Campaign No.2023100003, October 2023

SUBJECT: **Model SL (232 platform)**
Model Year 2022

Rework Connector Assignment in Trunk Fuse and Relay Module

Figure 3

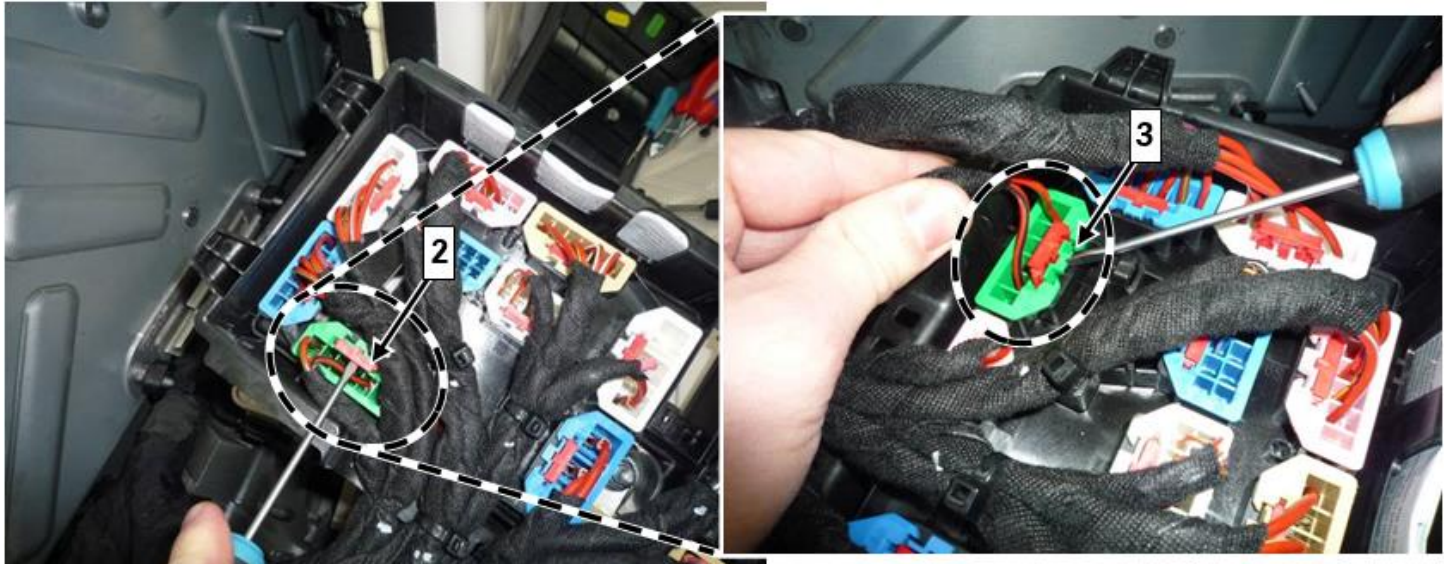
5. Release plug S1 (green) and disconnect from fuse and relay module.

i Pry lock (2, Figure 3) upwards with screwdriver.

i Press locking tab (3, Figure 3) towards plug with screwdriver.

Figure 5

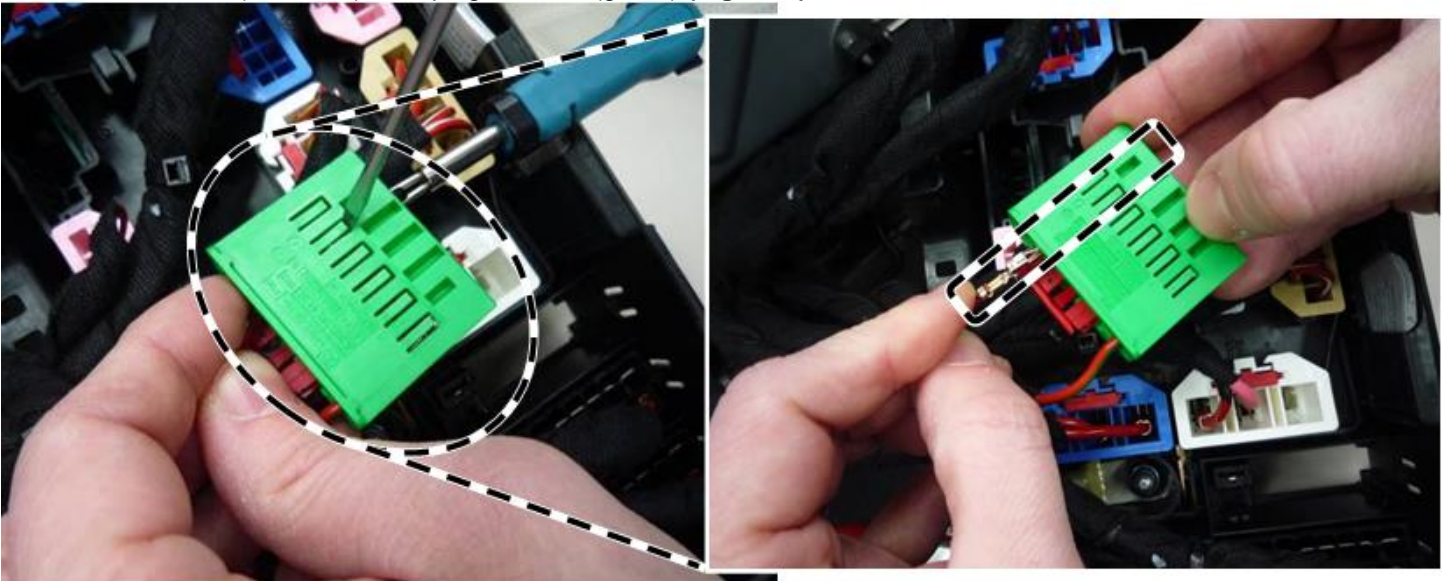
7. Disconnect line (red/black) from plug S1 **Pin2** (green) (**Figure 5**).

Figure 6

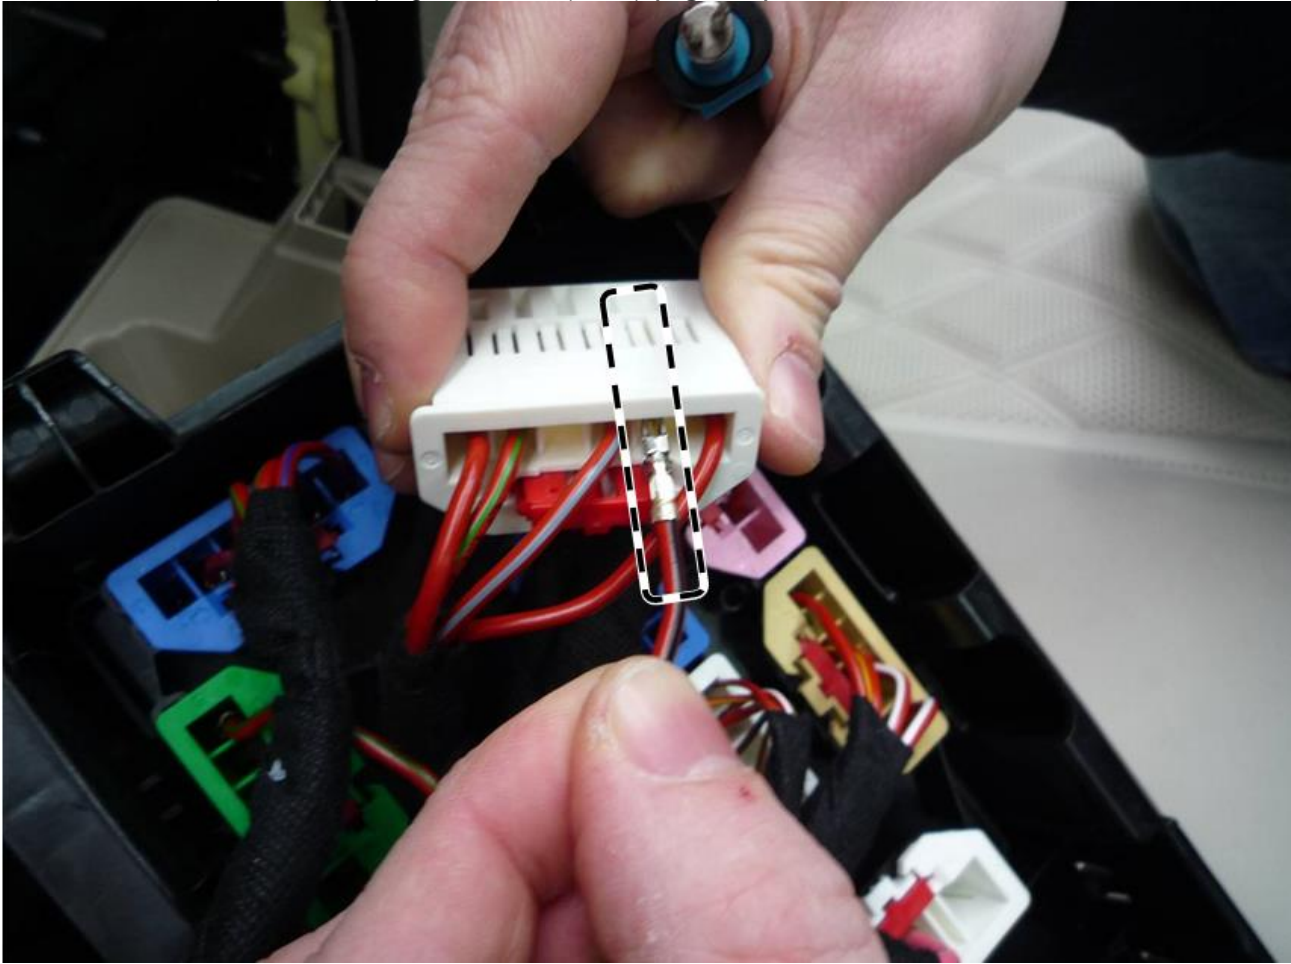
8. Relocate line (red/black) to plug S5 in **Pin5** (white) (**Figure 6**).

Figure 7

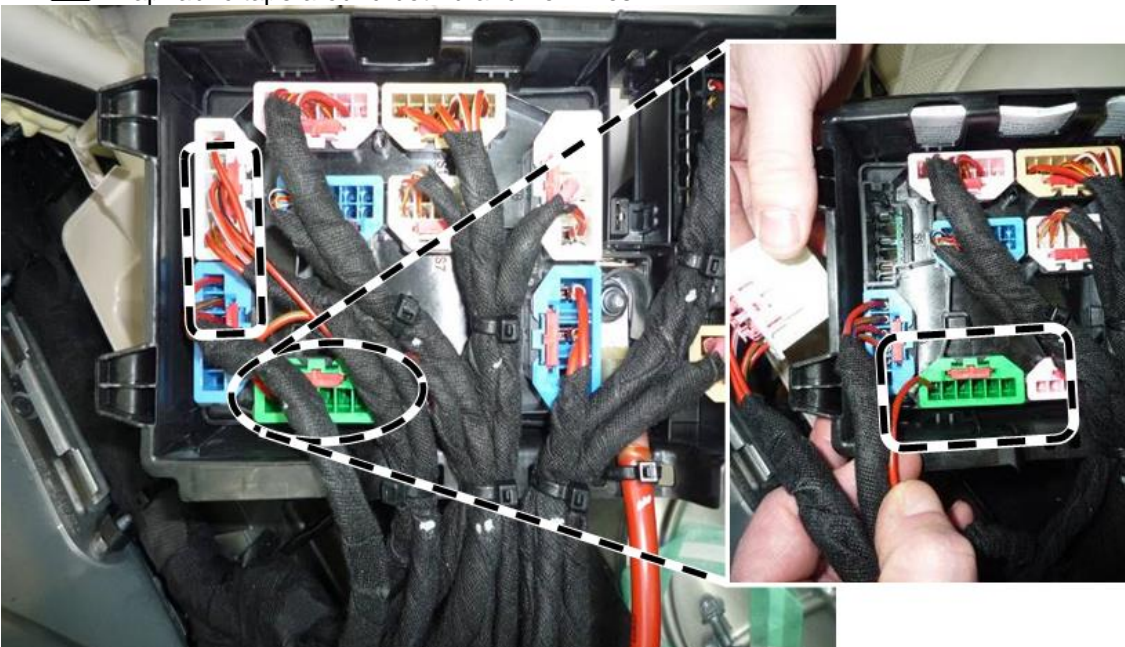
9. Connect plug S1 (**green**) and plug S5 (**white**) to the fuse and relay module (**Figure 7**).

i Wrap fabric tape around both branch-off lines
